From: [REDACTED]
Sent: 10 February 2026 10:54
To: Anna Tidey
Subject: RE: DM/25/3101 & DM/25/3102 - Discharge of conditions application/ Variation of condition application - Blackbirds, Bramble Hill, Balcombe

Thank you for omitting the metal flue and an Air Source Heat Pump (ASHP) from the plans (Proposed Plans and Elevations -Drawing No 02 REV 09), received on 02.02.2026, for the Variation of condition application under DM/25/3101. I will save the amended plans to the planning records and request that this application is made Valid again.

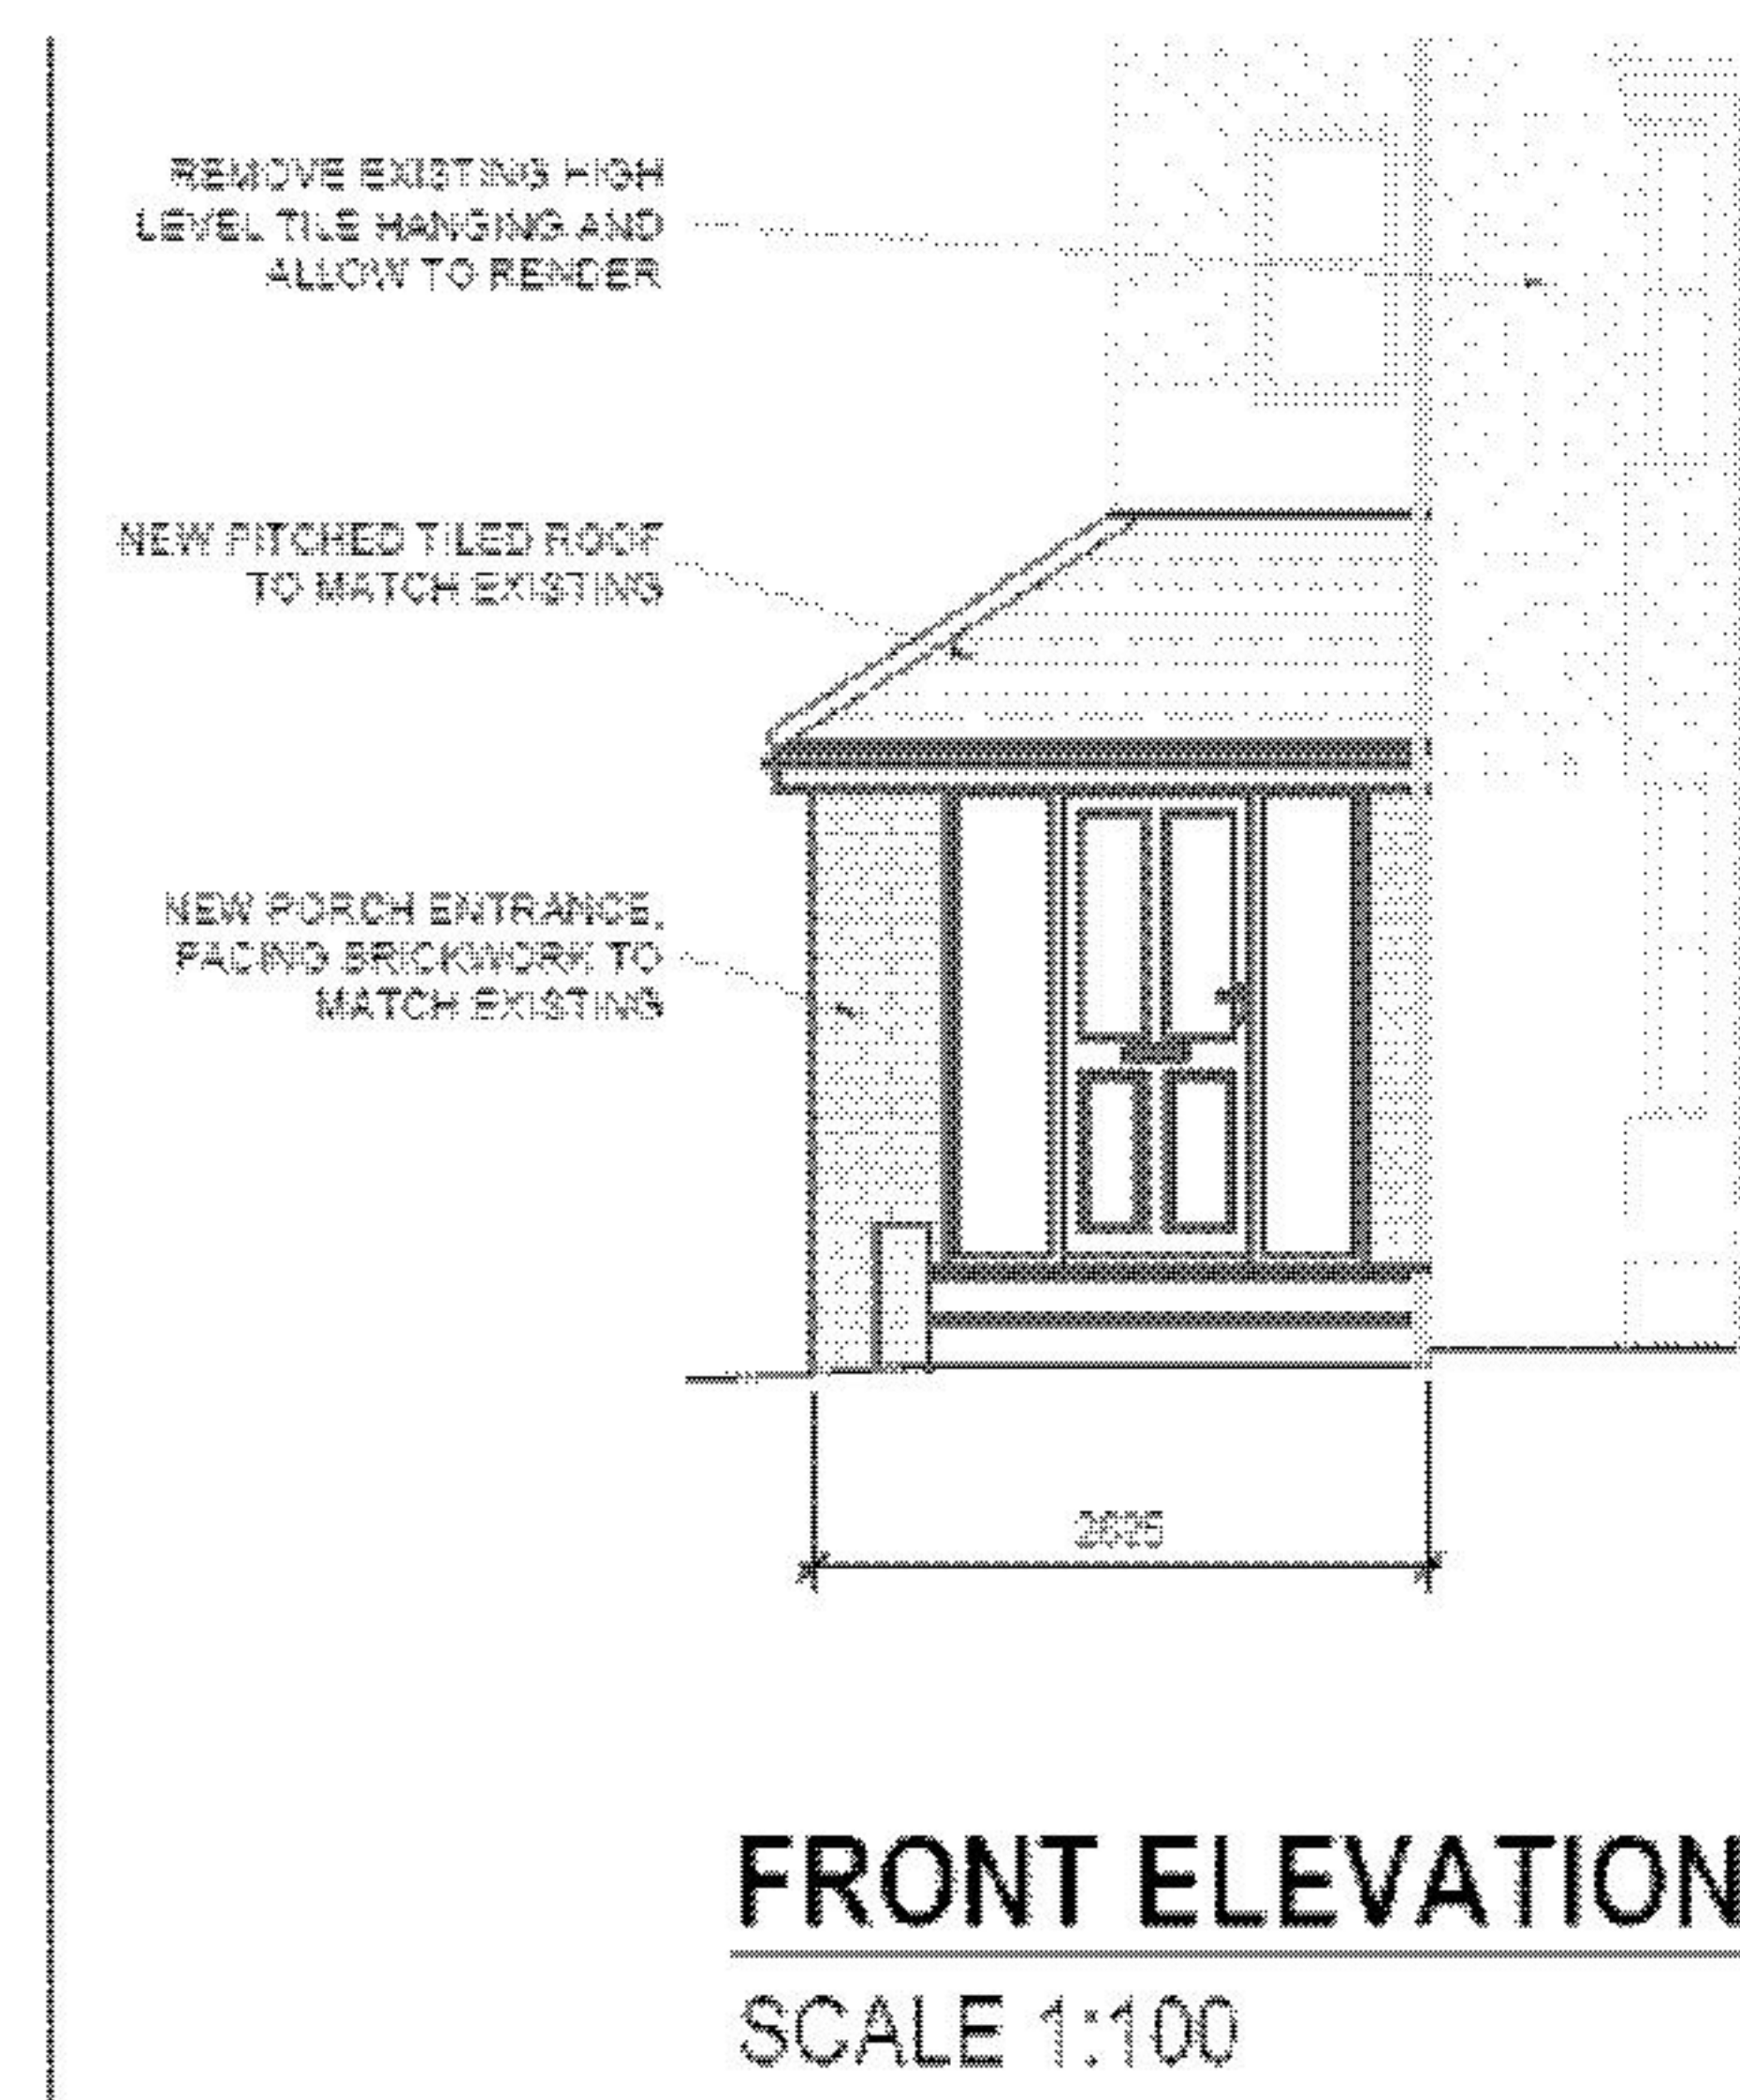
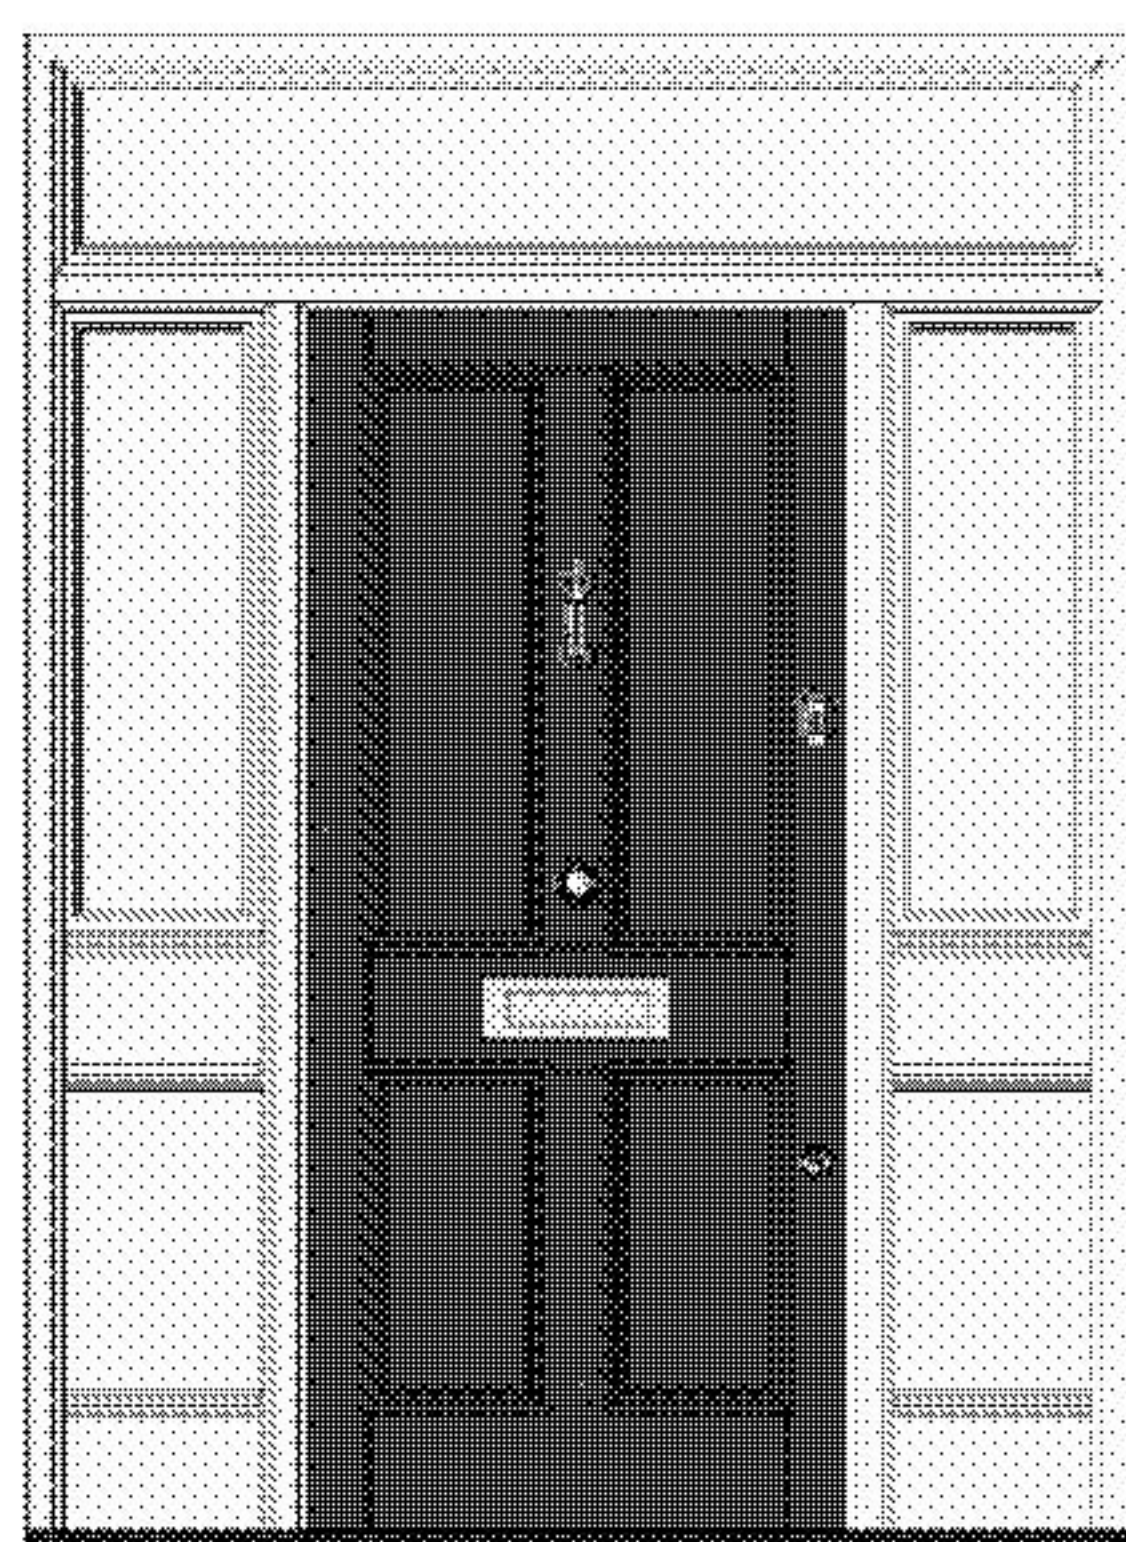
Thank you for your email regarding **DM/25/3102 - Discharge of conditions application**, the content of which I will review with Emily Wade. I note that the submitted front door detail does not correspond to the door design/glazing layout as shown on Proposed Floor and Elevations Plan No1252-02 Rev 05, as approved under DM/25/0873, see copied images below:

The submission of material details for discharge should accord with the Approved Plans showing the design which is to be implemented. A decision will not be made on this application as I have made the application INVALID pending further information on this point.

The front doorway is to be amended to that shown on Proposed Plans & Elevations Drawing No 02, Rev 8, as submitted under DM/25/3101. Please advise the best way forward regarding the validation / approval of each application.

You may wish to await approval of amended plans ahead of applying for the discharge of the materials condition. Please can you confirm if the front doorway is to be amended to that shown on Proposed Plans & Elevations Drawing No 02, Rev 8, as submitted under DM/25/3101?
